AGENDA ITEM SUMMARY / STAFF REPORT
FLORENCE PLANNING COMMISSION

ITEM NO: 4
Meeting Date: December 12, 2023

ITEM TITLE: PC 23 08 DR 02 – *Dollar General Design Review*

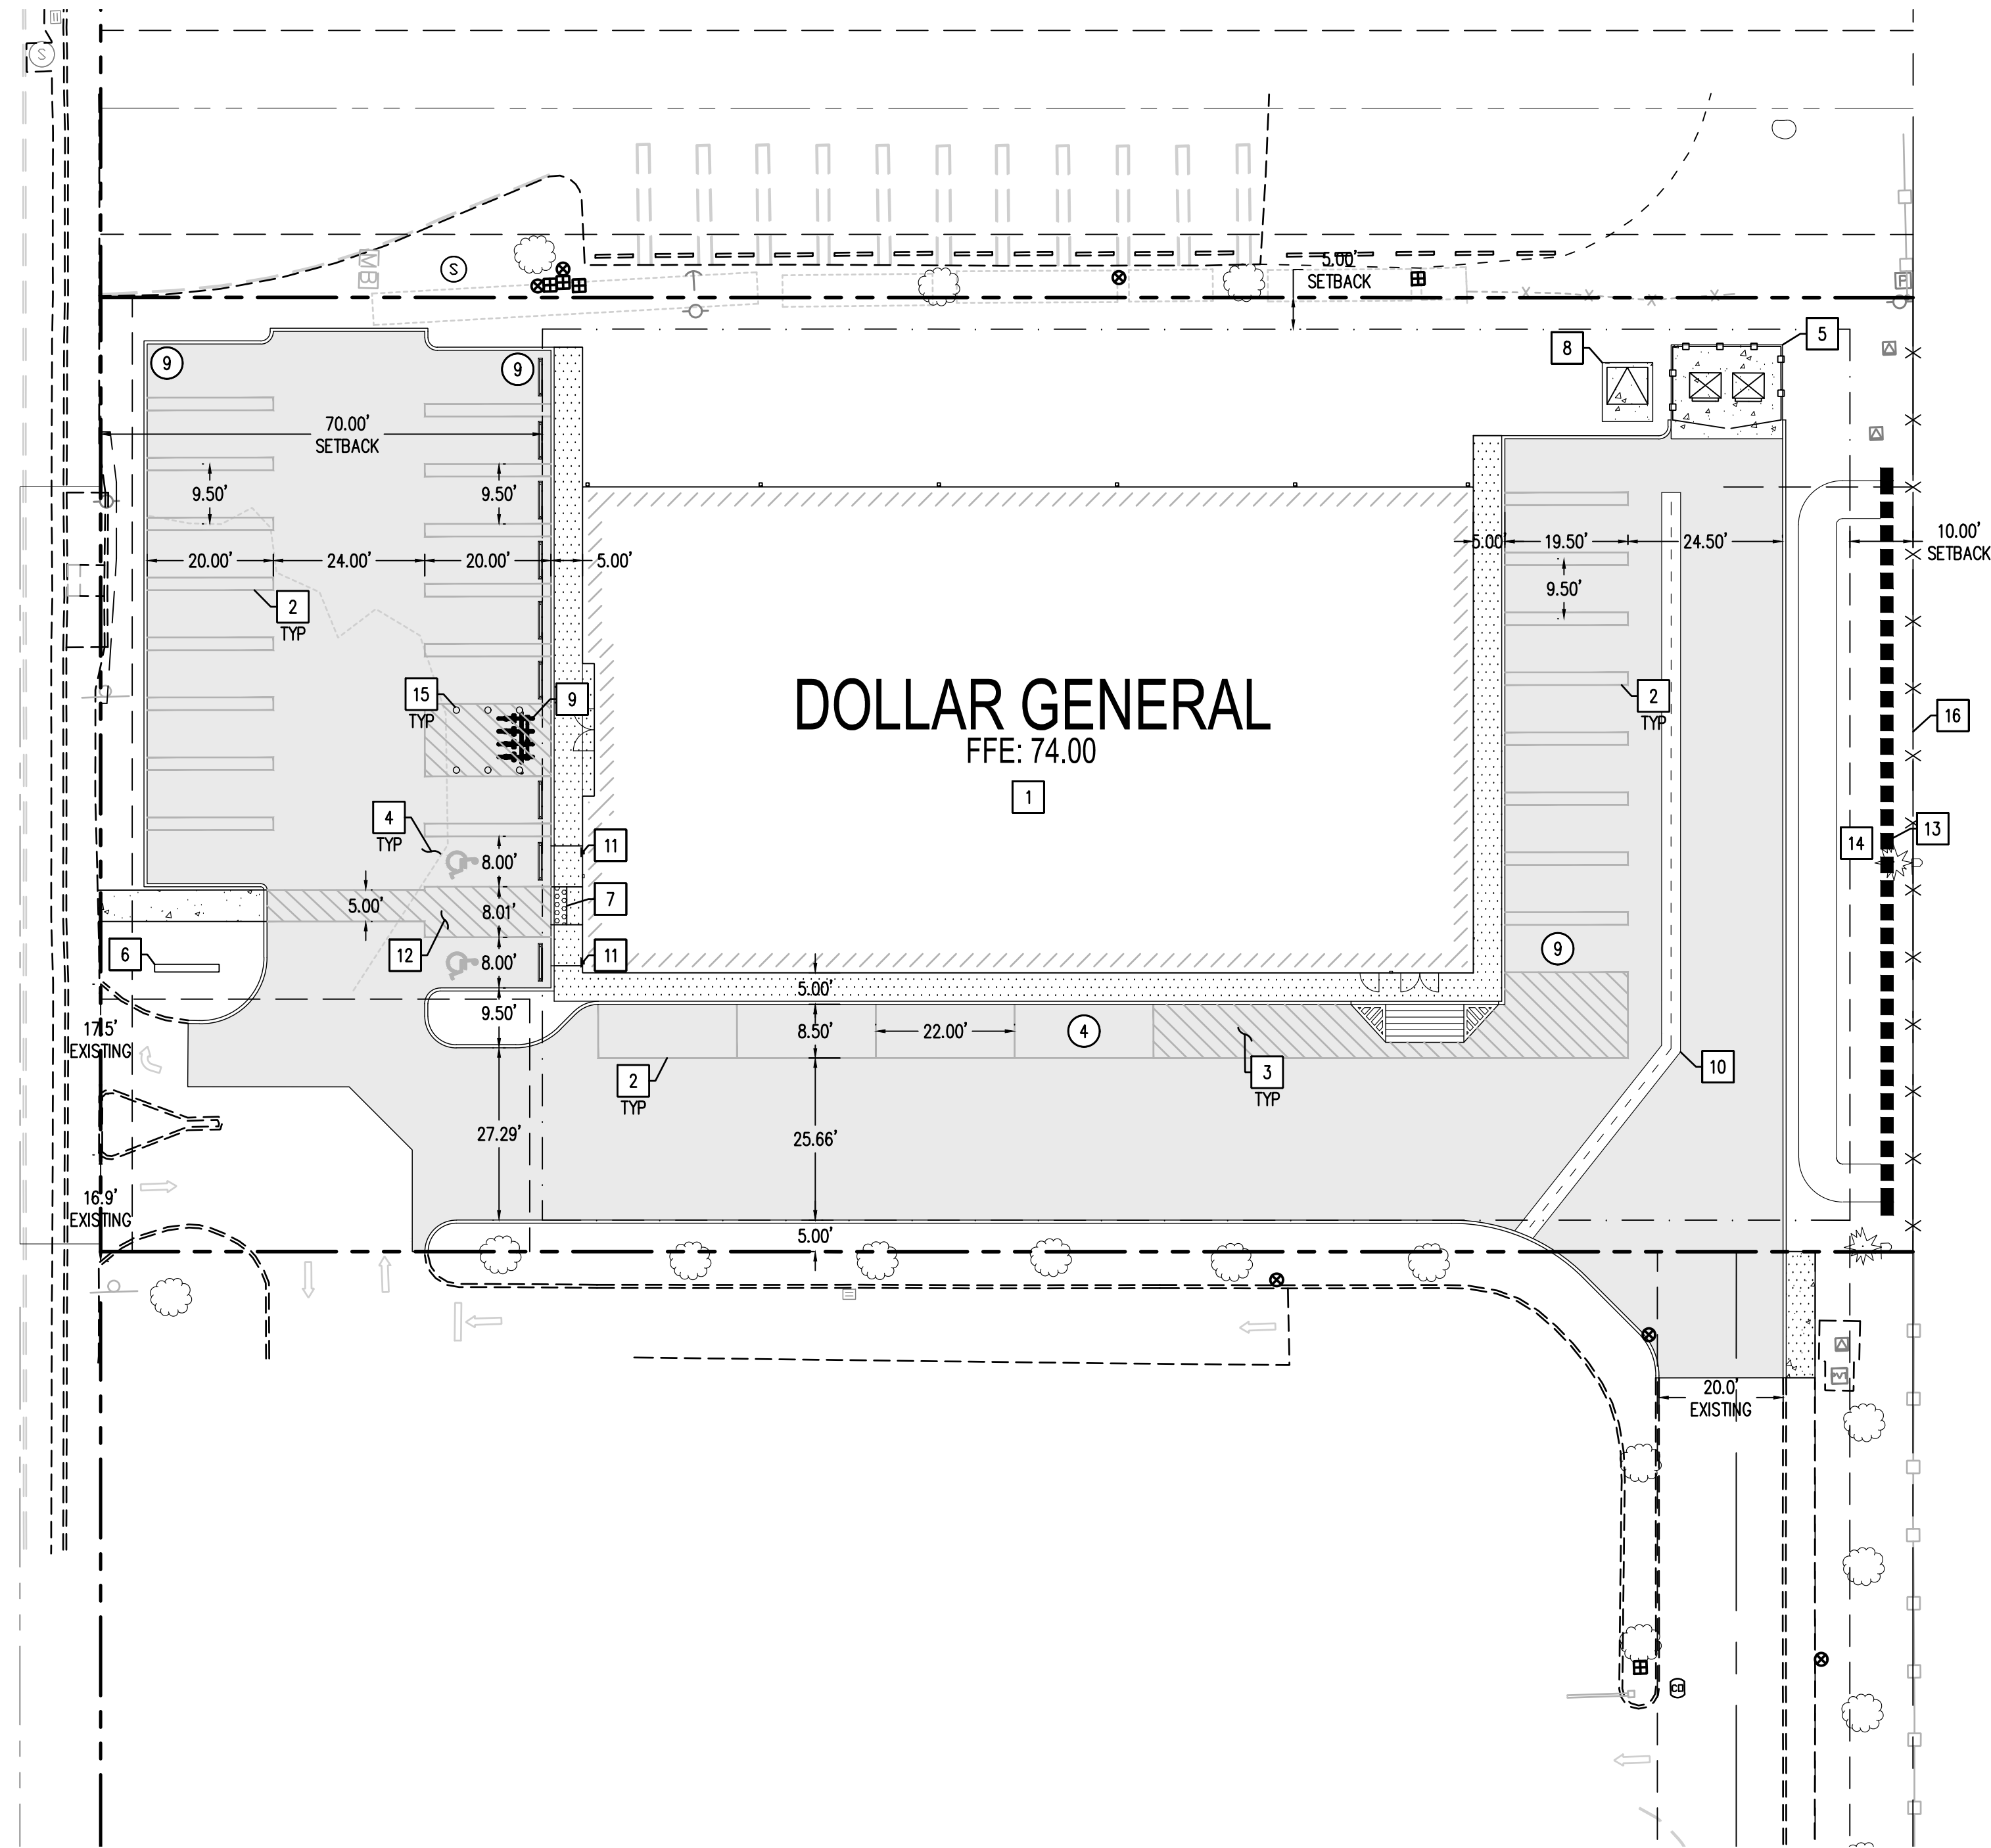
Condition 4-6: Aside from a minor edit, this condition concerning the bicycle parking area now contains language requiring barriers to protect the area from vehicle encroachment. The applicants submitted an updated site plan demonstrating the barriers (Exhibit C1, Sheet SP-01);

In response to a discussion by the Planning Commission during the November 14, 2023 public hearing regarding the need for barriers, the applicant submitted a revised site plan (Sheet SP-01 of Exhibit C1) which now contains safety bollards at each corner of the bicycle parking area to prevent vehicles from entering the bicycle parking area. Additionally, the bollards are labeled as Note 15 on the same sheet. Condition 4-6 has been amended accordingly:

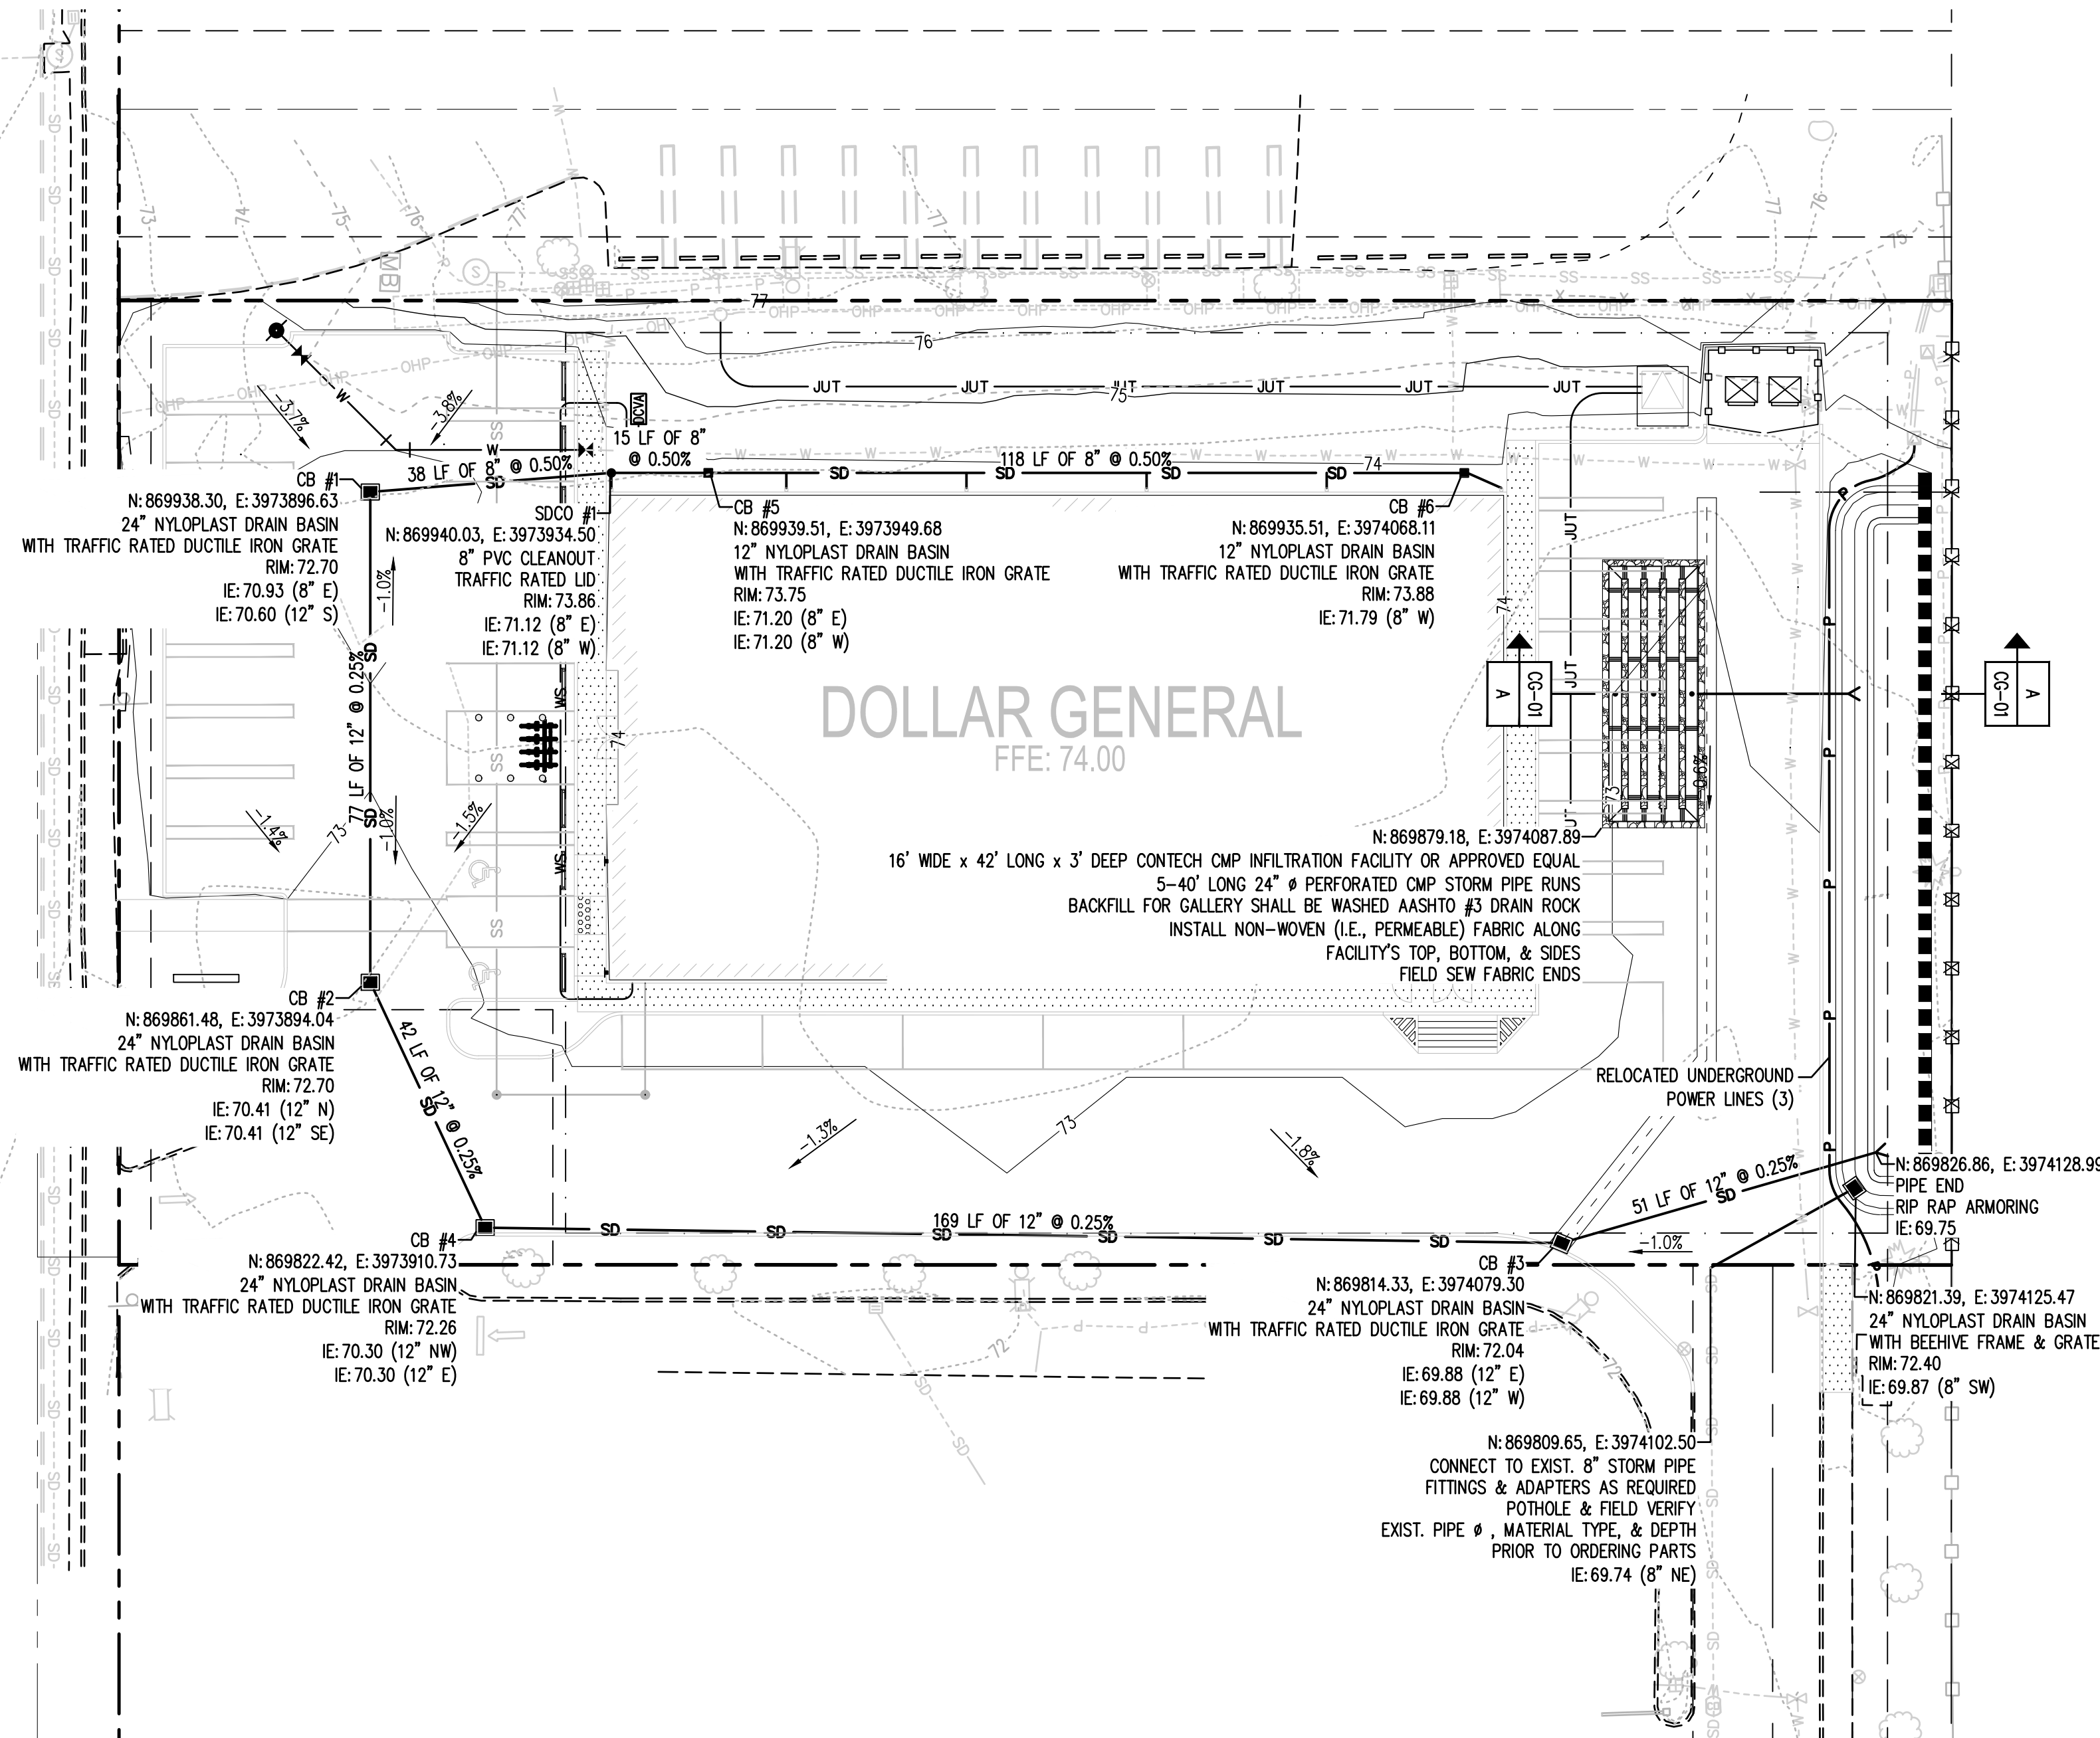
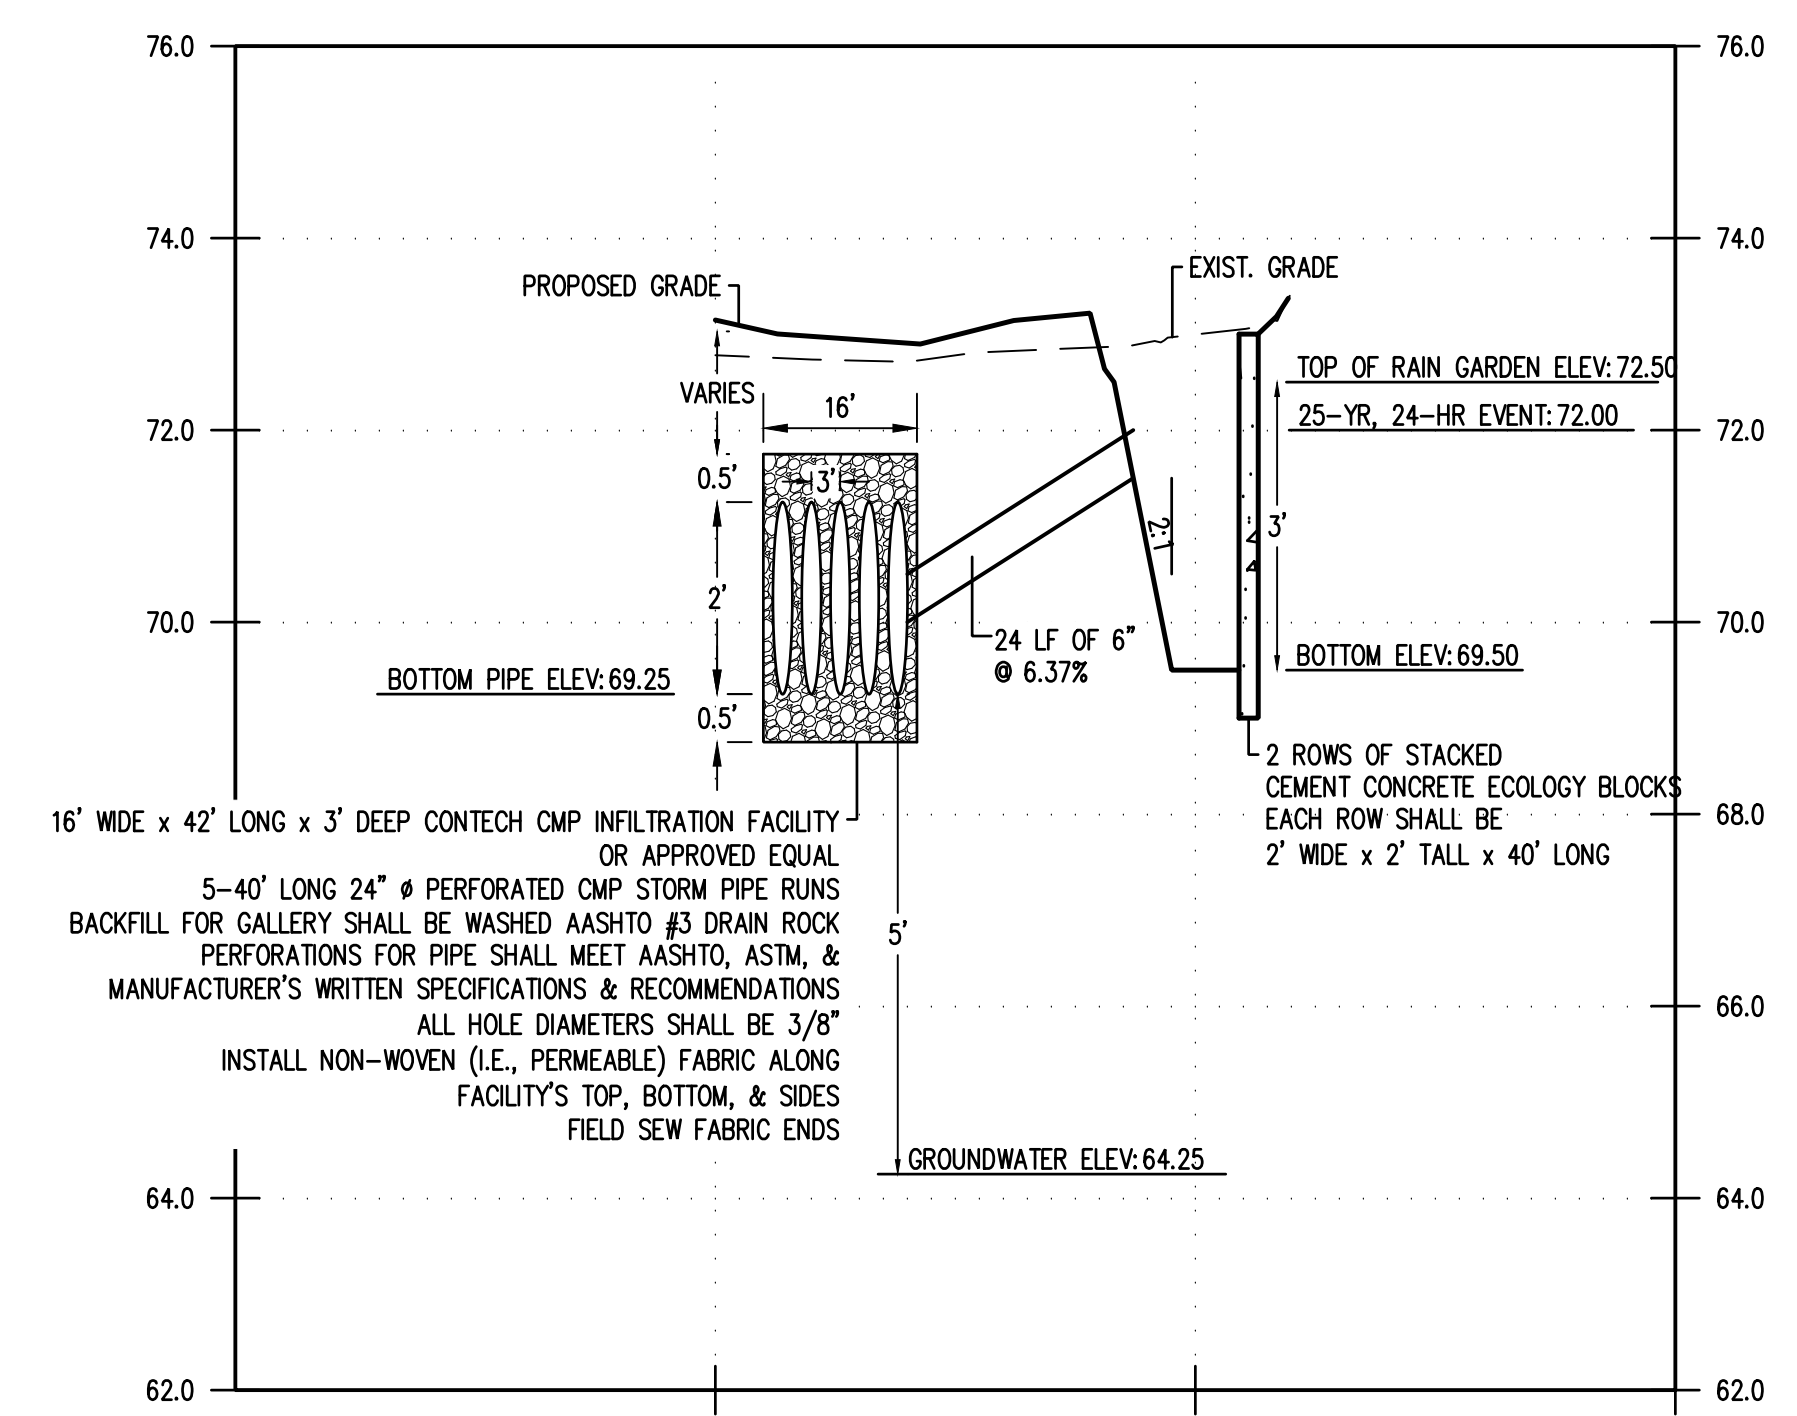
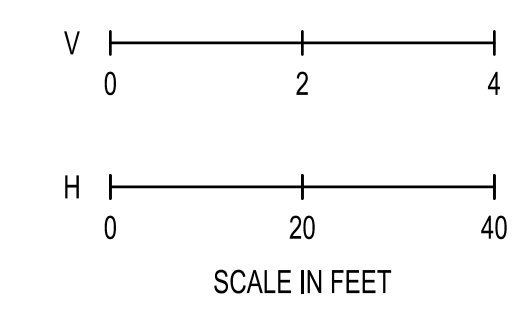
Condition 11-5: which is in reference to the elevation of the pipe inlet leading into the infiltration facility, which needs to be higher than the 25 year flood event height of 72' and lower than the overflow rim at the south end of the rain garden.

- 11-4. Stormwater rain gardens and accompanying underdrain facilities shall not be lined with impermeable materials.
- 11-5. The profile Section A-A and full plan on Sheet CG-01 do not illustrate the top of pipe inlet elevation at the rain garden leading to the infiltration facility. It is noted in the profile that the 25-year flood event occurs at 72'. Therefore, the pipe inlet into

The profile Section A-A and full plan on Sheet CG-01 do not illustrate the top of pipe inlet elevation at the rain garden leading to the infiltration facility. It is noted in the profile that the 25-year flood event occurs at 72'. Therefore, the pipe inlet into the infiltration facility must be higher than 72.00' and less than the bottom of the overflow rim of 72.40 at the south end of the rain garden. [Condition 11-5]
